Engineering Bulletin Simplified Aircraft/Engine Repair (EB-SR)

EB-SR-No. 00161964/001

Elongated Fastener Holes at the LH Underwing Fixed Panel Seal Retainer and Retainer Angle

Product / (A/C type or Engine type) A320 / A320-214	ATA 57-51-37	OEM-Reference (e.g. SB, AMM, EM, CMM, IPC) DLH AMM [Rev.113 MAY 01/2019]
---	------------------------	--

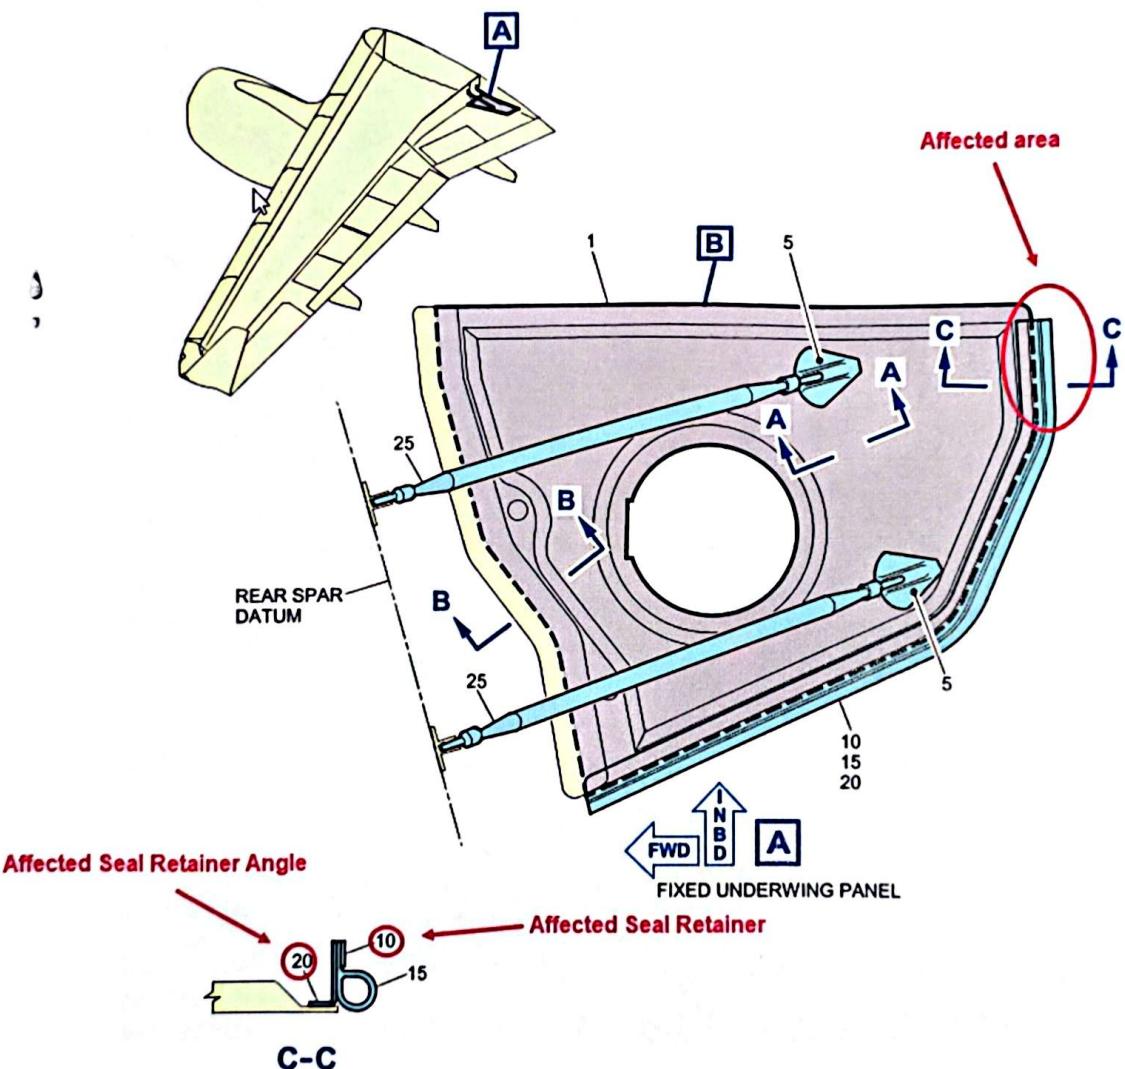
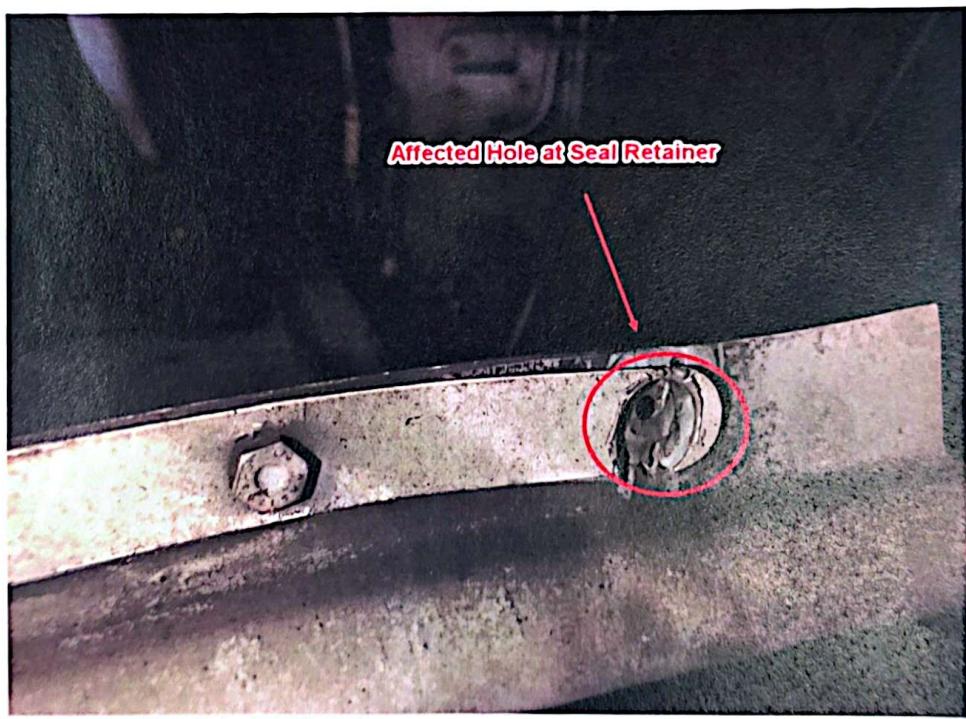
During maintenance work in zone 571 on the fixed under wing panel one fastener hole at the seal retainer and seal retainer angle was found elongated.

Currently for seal retainer angle, no spare part is available. Therefore, the operator request a deferral of the final rectification.

For location and details refer to sketches below:

1. Remove the seal retainer PN D5754125820200.
2. Perform a detailed visual inspection to ensure that no additional damage is present in the affected area.
3. If required perform a cleanup of the affected fastener hole at the seal retainer angle.
4. Install a new seal retainer PN D5754125820200.
5. Install the affected seal part as per AMM requirements. Use the original fastener type and install washer PN AN970-3 on seal retainer angle side.
Make sure that the thread from the fastener is minimum 3 turns visible. If required adapt the grip length of the fastener.
6. Open a deferred Item index O for re-inspections every 250FH to ensure good condition of the performed repair.
7. Open a deferred item for replacement of the seal retainer angle PN D5754125820000 within 500FH.
